REFERENCE:
BULLETIN 25-268

DC-9

SUBJECT: EQUIPMENT/FURNISHINGS -
Lavatories - Modify
Forward and Aft Lavatory
Waste Container Assemblies.

EQUIPMENT/FURNISHINGS - Lavatories - Modify Forward and Aft Lavatory Waste Container Assemblies.

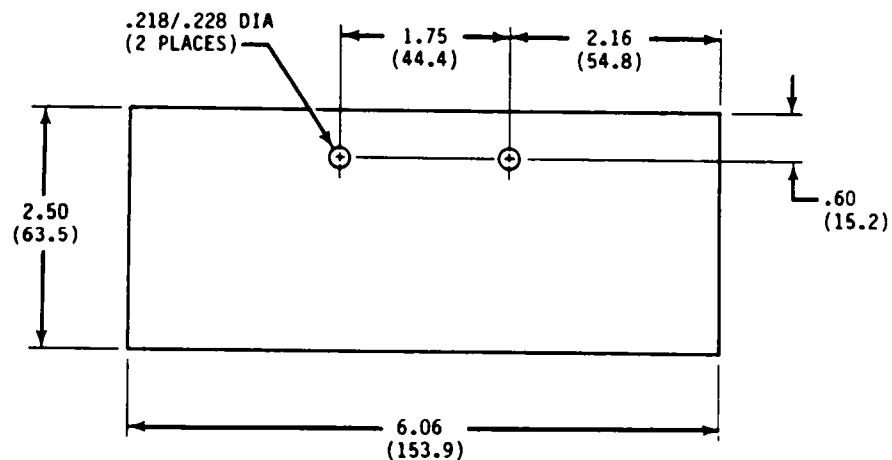
- A. Fabricate hinge assembly locating tool (one required) from 6061-T6 aluminum clad sheet, .030 X 3 X 7 inches. Material Specification QQ-A-250/11, Temper T6. Identify as SR09250003-13. (See Sketch.)
- B. SB09250268-7001 Kit - Modify forward lavatory towel waste container as shown on Figure 1.
- C. SB09250268-7003 Kit - Modify aft lavatory towel waste container as shown on Figure 2.

FABRICATE HINGE ASSEMBLY LOCATING TOOL (ONE REQUIRED) FROM 6061-T6 ALUMINUM CLAD SHEET, .020 X 3 X 7 INCHES, MATERIAL SPECIFICATION QQ-A-250/11, TEMPER T6. IDENTIFY AS SR09250003-13.

FIGURE 1 (SHEET 1 OF 6)

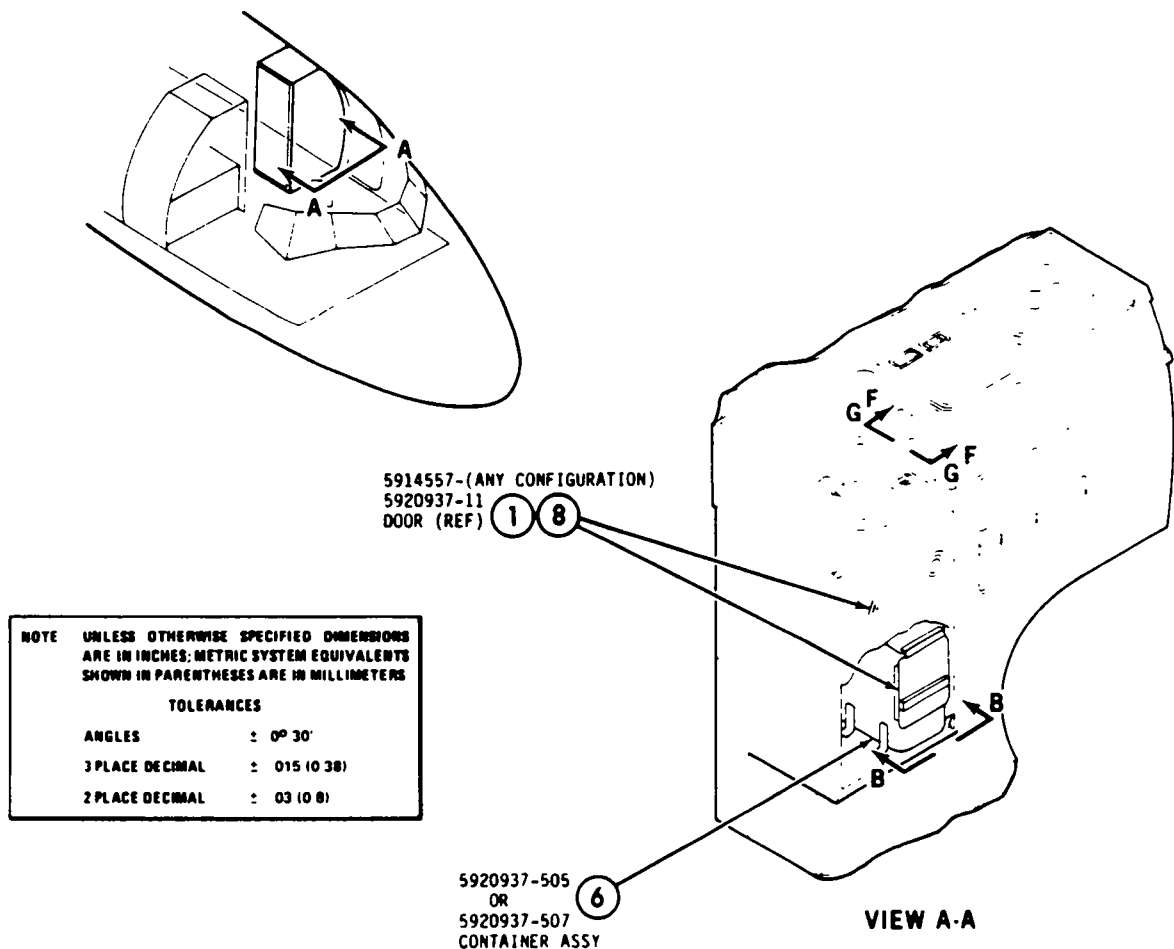
- ① OPEN AND SECURE 5914557-(ANY CONFIGURATION) AND 5920937-11 DOORS FOR ACCESS TO REPAIR AREA OF CONTAINER ASSEMBLY.
- ② CLEAN INSIDE OF CONTAINER ASSEMBLY BELOW DOOR OPENING PER CHAPTER 51-70-1 PARAGRAPH ENTITLED "REPAIR AREA PREPARATION AND CLEANING."
- ③ POSITION SR09250003-3 PLATE AND SECURE USING SR09250003-5 TAPE.
- ④ CUT THREE PIECES OF SR09250003-7 CLOTH 2 X 7 INCHES AND LAYUP PER CHAPTER 51-70-3, PARAGRAPH ENTITLED "GLASS FIBER LAYUP TO METAL REPAIRS."

- ⑦ REFORM DOOR AS REQUIRED TO MAINTAIN .030 (.76) INCH MAXIMUM CLEARANCE BETWEEN DOOR AND CONTAINER.
- ⑧ CLOSE CONTAINER AND CABINET DOOR.
- ⑨ REMOVE 4914565-1 OR -501 DOOR ASSEMBLY AS FOLLOWS:
 - a. 4914565-1 - SEPARATE 4914565-3 DOOR FROM 4914565-5 HINGE HALF USING A SHARP EDGED CHISEL.
 - b. 4914565-501 - REMOVE TWO MS51957-44 SCREWS.
- ⑩ REMOVE 4914565-7 HINGE FROM CABINET AS FOLLOWS:
 - a. SAND FIBERGLASS FROM SURFACE OF HINGE.
 - b. USING A SHARP EDGE CHISEL, PRY HINGE FROM CABINET.
 - c. REMOVE S224504259-320 PIN AND S133509-12 SPRING.
 - d. REMOVE RESIN AND GLASS CLOTH TO SMOOTH CABINET SURFACE.

FIGURE 1 (SHEET 2 OF 6)

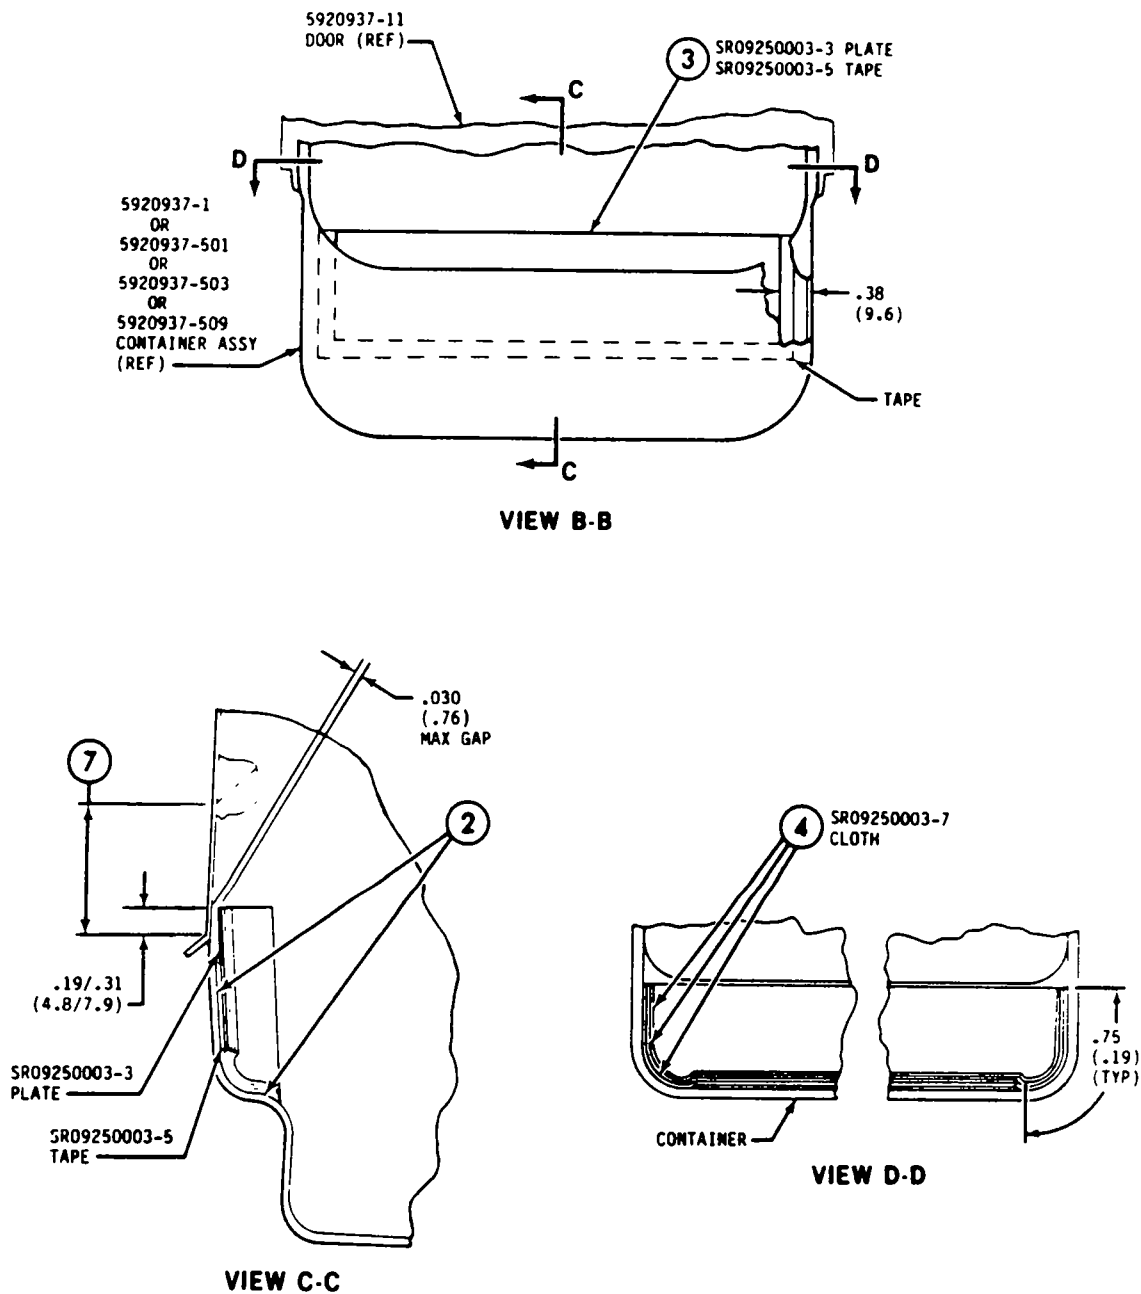
- ⑪ CLEAN AREA PER CHAPTER 51-70-03, PARAGRAPH ENTITLED "GLASS FIBER LAYUP TO METAL REPAIRS," AND INSTALL SR09250003-19 BRACKET ASSEMBLY AS FOLLOWS:

- ATTACH SR09250003-17 HINGE ASSEMBLY (TEMPORARILY OMIT 4956762-1 SPRING) TO SR09250003-13 LOCATING TOOL AND SR09250003-19 BRACKET ASSEMBLY USING NEW S2245042S9-320 HINGE PIN AND FOUR MS51957-44 SCREWS.

- CENTER LOCATING TOOL IN OPENING, FLUSH AGAINST TRIM SURFACE OF CABINET.
 - BOND SR09250003-19 BRACKET TO CABINET AND ALLOW TO CURE.
 - REMOVE SR09250003-17 HINGE ASSEMBLY AND SR09250003-13 LOCATING TOOL.

- LAYUP TWO LAYERS OF SR09250003-23 GLASS CLOTH ON SR09250003-19 BRACKET ASSEMBLY EXTENDING 1.00 (25.4) INCH FROM BRACKET ON THREE SIDES PER CHAPTER 51-70-3, PARAGRAPH ENTITLED "GLASS FIBER LAYUP TO METAL REPAIRS."

- ⑫ INSTALL SR09250003-17 HINGE ASSEMBLY WITH 4956762-1 SPRING INSTALLED, ON SR09250003-19 BRACKET ASSEMBLY.
- ⑬ INSTALL SR09250003-21 DOOR AND VERIFY THAT DOOR SEALS AGAINST CABINET TRIM SURFACE.

FIGURE 2 (SHEET 1 OF 6)

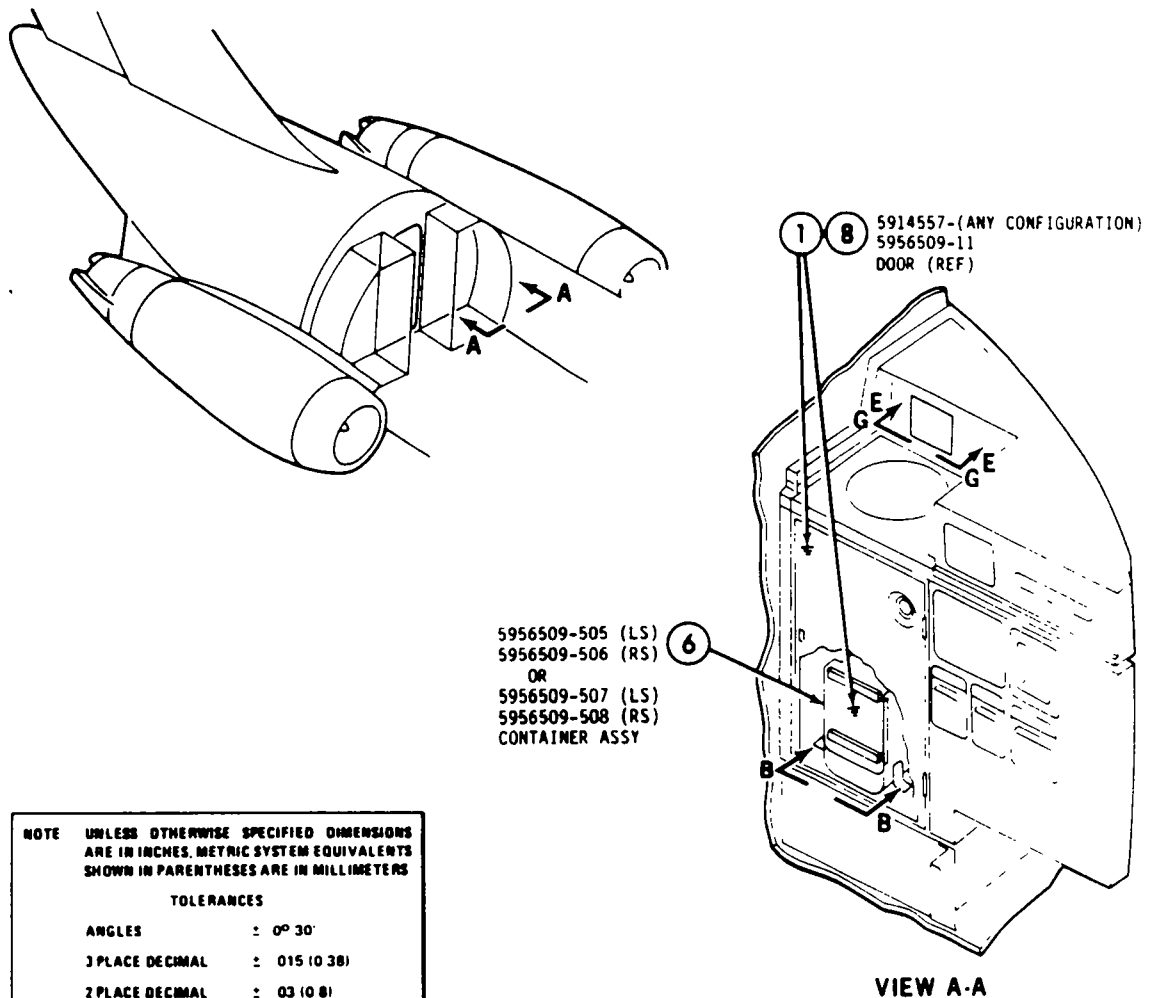
- ① OPEN AND SECURE 5914557-(ANY CONFIGURATION) AND 5956509-17 DOORS FOR ACCESS TO REPAIR AREA OF CONTAINER ASSEMBLY.
- ② CLEAN INSIDE OF CONTAINER ASSEMBLY BELOW DOOR OPENING PER CHAPTER 51-70-1 PARAGRAPH ENTITLED "REPAIR AREA PREPARATION AND CLEANING."
- ③ POSITION SR09250003-9 PLATE AND SECURE USING SR09250003-5 TAPE.
- ④ CUT THREE PIECES OF SR09250003-7 CLOTH 2.5 X 9 INCHES AND LAYUP PER CHAPTER 51-70-3, PARAGRAPH ENTITLED "GLASS FIBER LAYUP TO METAL REPAIRS."

- ⑦ REFORM DOOR AS REQUIRED TO MAINTAIN .030 (.76) INCH MAXIMUM CLEARANCE BETWEEN DOOR AND CONTAINER.
- ⑧ CLOSE CONTAINER AND CABINET DOOR.
- ⑨ REMOVE 4914565-1 OR -501 DOOR ASSEMBLY AS FOLLOWS:
 - a. 4914565-1 - SEPARATE 4914565-3 DOOR FROM 4914565-5 HINGE HALF USING A SHARP EDGED CHISEL.
 - b. 4914565-501 - REMOVE TWO MS51957-44 SCREWS.
- ⑩ REMOVE 4914565-7 HINGE FROM CABINET AS FOLLOWS:
 - a. SAND FIBERGLASS FROM SURFACE OF HINGE.
 - b. USING A SHARP EDGE CHISEL, PRY HINGE FROM CABINET.
 - c. REMOVE S2245042S9-320 PIN AND S133509-12 SPRING. RETAIN S2245042S9-320 PIN.
 - d. REMOVE RESIN AND GLASS CLOTH TO SMOOTH CABINET SURFACE.

FIGURE 2 (SHEET 2 OF 6)

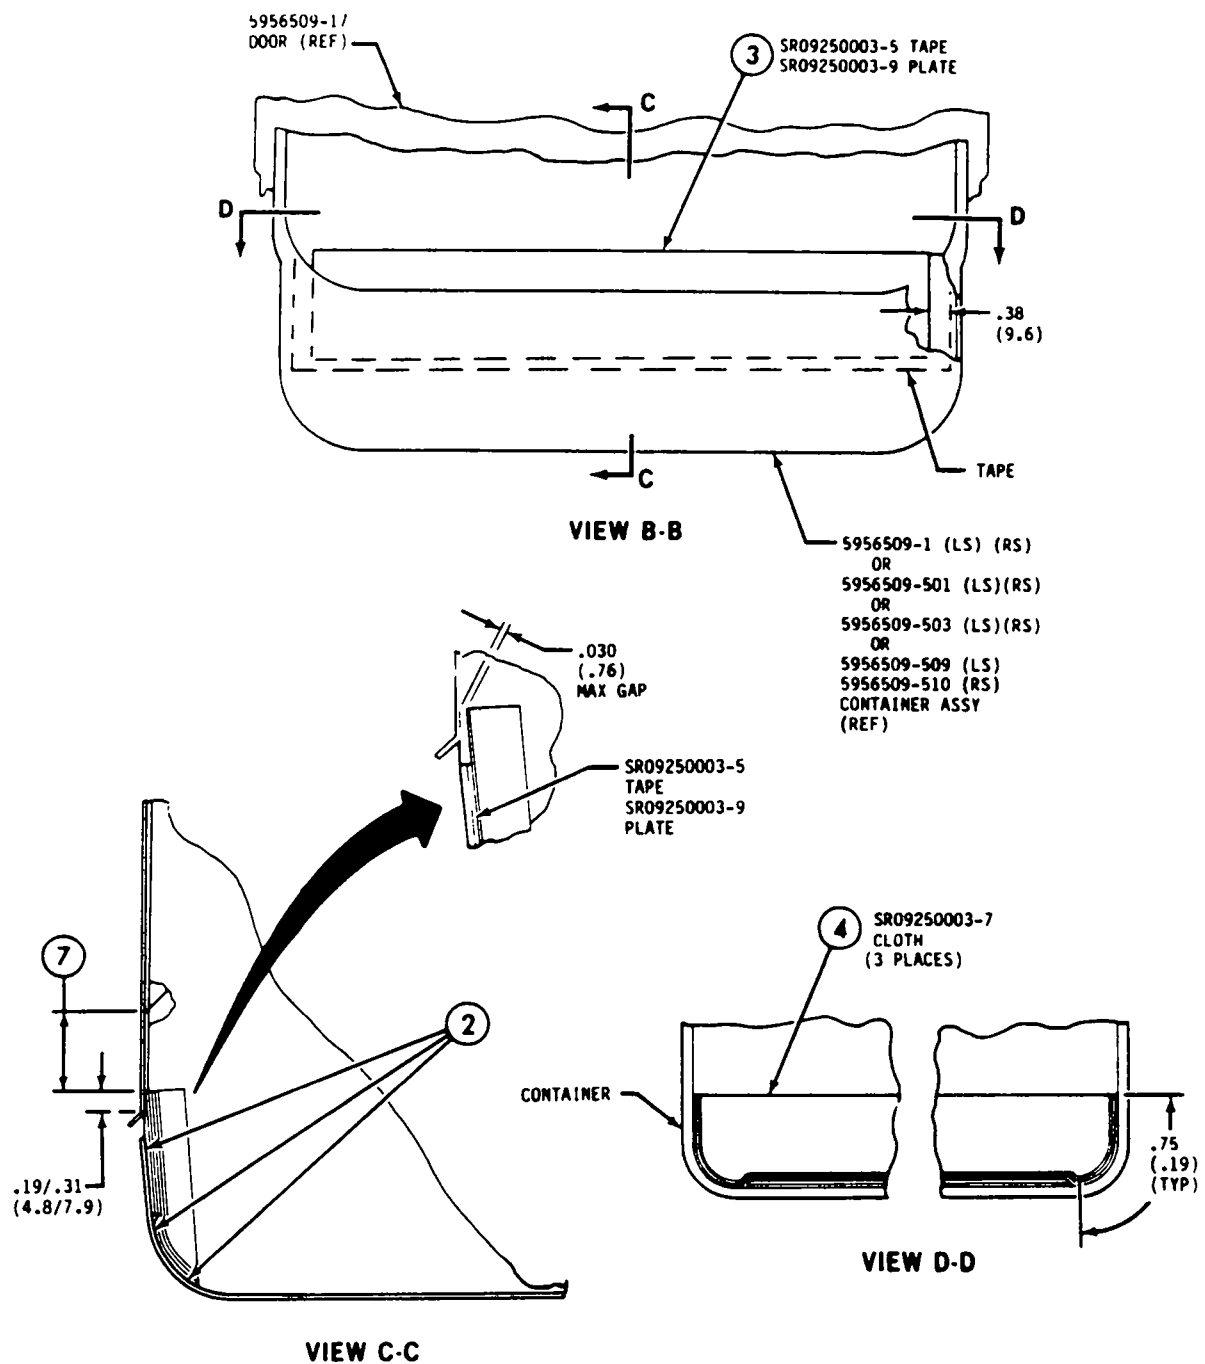
- ⑪ CLEAN AREA PER CHAPTER 51-70-03, PARAGRAPH ENTITLED "GLASS FIBER LAYUP TO METAL REPAIRS." AND INSTALL SR09250003-19 BRACKET ASSEMBLY AS FOLLOWS:

- a. ATTACH SR09250003-17 HINGE ASSEMBLY (TEMPORARILY OMIT 4956762-1 SPRING) TO SR09250003-13 LOCATING TOOL AND SR09250003-19 BRACKET ASSEMBLY USING NEW S224504259-320 HINGE PIN AND FOUR MS51957-44 SCREWS.

- b. CENTER LOCATING TOOL IN OPENING, FLUSH AGAINST TRIM SURFACE OF CABINET.
 - c. BOND SR09250003-19 BRACKET TO CABINET AND ALLOW TO CURE.
 - d. REMOVE SR09250003-17 HINGE ASSEMBLY AND SR09250003-13 LOCATING TOOL.

- e. LAYUP TWO LAYERS OF SR09250003-23 GLASS CLOTH ON SR09250003-19 BRACKET EXTENDING 1.00 (25.4) INCH FROM BRACKET ON THREE SIDES PER CHAPTER 51-70-3, PARAGRAPH ENTITLED "GLASS FIBER LAYUP TO METAL REPAIRS."

- ⑫ INSTALL SR09250003-17 HINGE ASSEMBLY WITH 4956762-1 SPRING INSTALLED ON SR09250003-19 BRACKET ASSEMBLY.
- ⑬ INSTALL SR09250003-21 DOOR AND VERIFY THAT DOOR SEALS AGAINST CABINET TRIM SURFACE.
